RE: Application of Orange County-Poughkeepsie Limited Partnership d/b/a Verizon
Wireless -110 Howland Avenue

Please accept this letter as Verizon Wireless' response to the comments provided in the John Clarke Planning and Design January 11, 2019 letter in connection with the above referenced application. For ease of reference, Mr. Clarke's comments have been provided below in their entirety followed by our responses.

PROJECT NO.: 20161509173
SITE NAME:
HOWLAND MICRO

OVERALL SITE PLAN

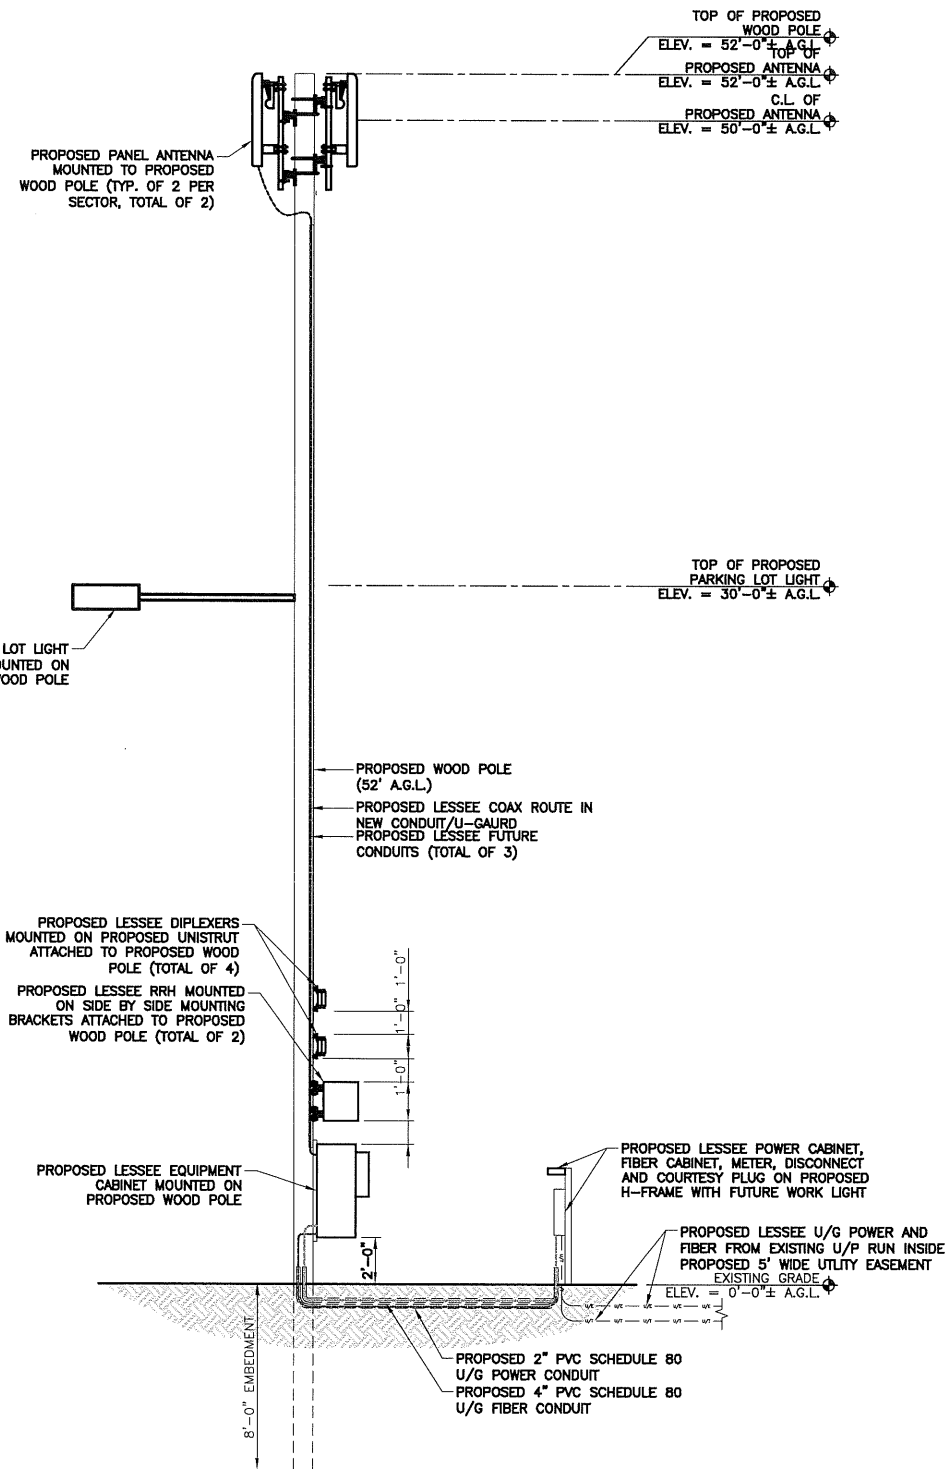
1. The Special Permit Application and Site Plan identify the parcel as in the R1-20 zoning district, but it is actually in the R1-40 district.

7. The Site Plan should show the setback distances from the tower to the residential building on the site and to the surrounding property lines, meeting the setback requirements in 223-24.5 E.

Response: The enclosed plans have been corrected to include the correct zoning district.

Response: The enclosed plans have been revised to include the requested information.

RE: Howland Application, Municipal Water Tank

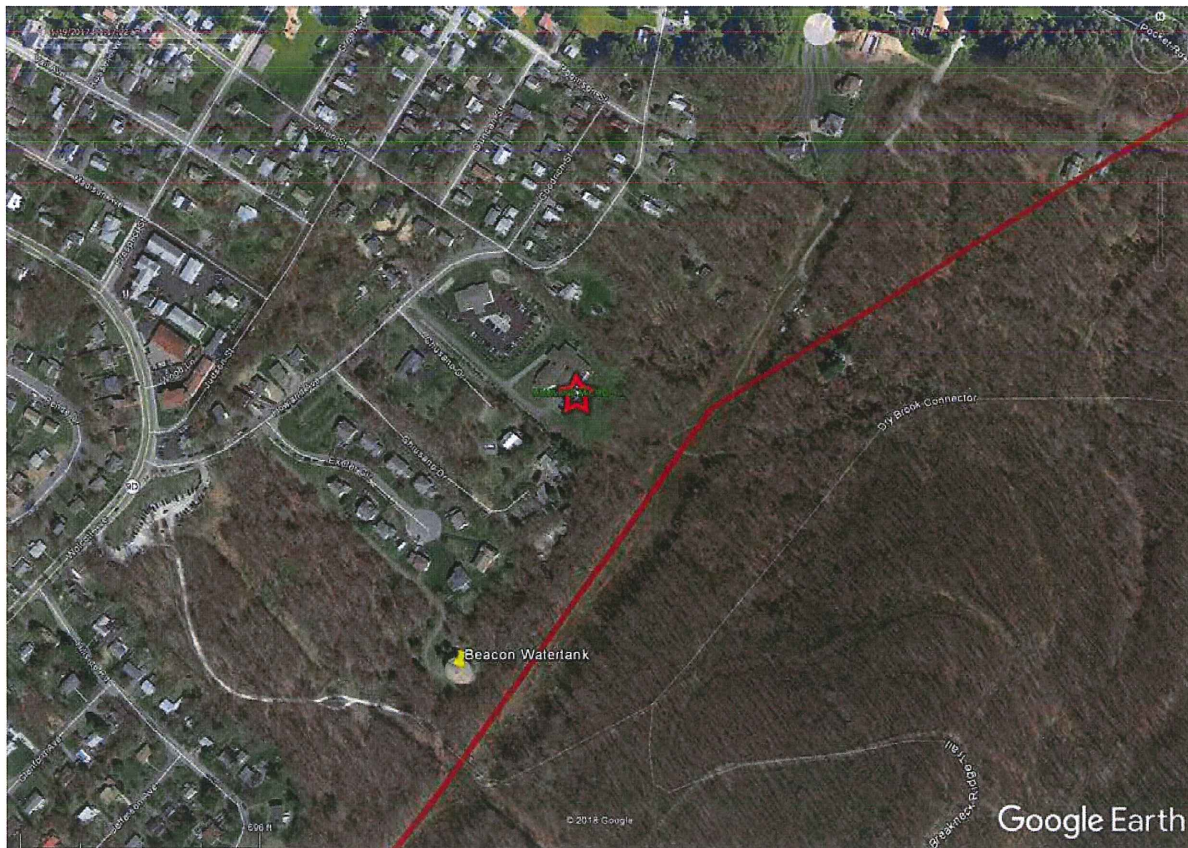
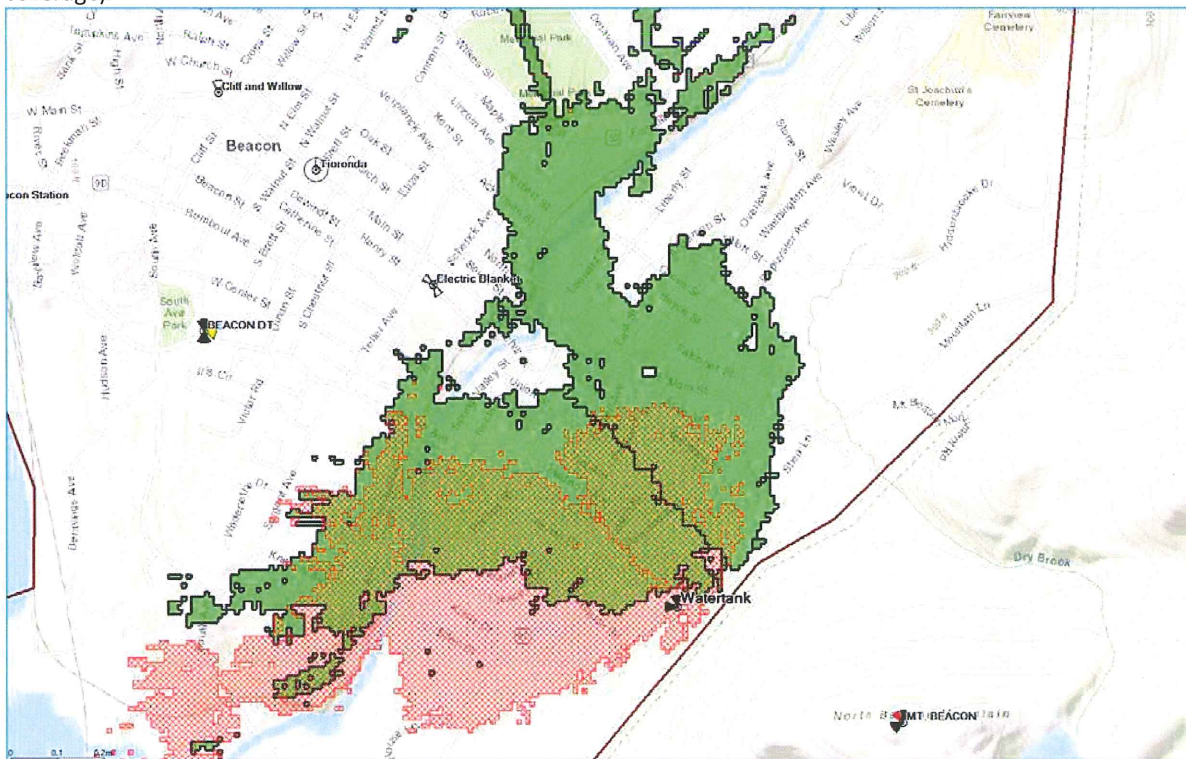
3. Sections 223-24.5 D(1)(a) and D(3) of the Zoning Code include as locational priorities that new facilities should be attached to a City-owned or existing structure, wherever possible. The application's Site Selection Analysis contains no specific information on consideration of alternative sites. Only two are listed as possibilities, both on the proposed property. For example, there is a City of Beacon water tower only 800 feet to the south that could have been investigated. The application should include a more detailed explanation of alternative properties (see also Section 223-24.5 R(4)).

A question was posed as to whether or not Verizon may be able to move the proposed installation to an alternate water tank location off Howland Ave near the Breakneck Ridge Trail.

We asked the Verizon Wireless RF Engineer to comment on the viability of using the water tank in place of the new wooden utility pole. As set forth in greater detail in the supplemental RF letter enclosed herewith, the water tank is not a viable candidate for collocation since it will provide significantly less coverage (approximately 50% less) compared to the proposed facility.

We have been aware of this water tank location and have reviewed it prior to and during the process of developing the proposed Howland site. This location has been deemed not of similar RF value for multiple reasons. It is critical to understand how the actual physical location of the Beacon Water Tank has much of its potential viewshed blocked by local obstructions. Additionally the water tank structure itself is lower in available ACL and approximately 800' south of the desired location and search area. For the purpose of comparison we have utilized the exact same pole and antenna configuration at each location.

The Beacon Water Tank location fails to achieve the Howland site objectives for the following reasons and is therefore RF Rejected:

1. Too low of position relative to its local obstructions. The water tank location compared to the proposed Howland location suffers from unacceptable signal degradation to the north due to far field (view) blocked by dense localized clutter. The dominant footprint that is necessary to offload the existing sites is not possible from this location due to being blocked by terrain and foliage. Having a clear line of sight (LOS) to area objectives is critical when designing new micro sites at cellular frequencies.
2. Poor positioning relative to some area objectives as well as other sites. The water tank is approximately 800' south of the identified search ring. This distance combined with the above mentioned obstructions further limit this locations ability to serve the necessary objectives and provide the necessary capacity offload detailed in the RF Justification.

The image below helps visualize the difference in coverage between the proposed Howland site (Green coverage footprint) and the Beacon Water Tank (Red hashed coverage footprint). Small cell facilities are designed to have smaller coverage footprints and therefore even a slight relocation of the site can significantly alter site performance. As can be seen in the plot below...the water tank site would not serve the intended area (~50% less coverage).
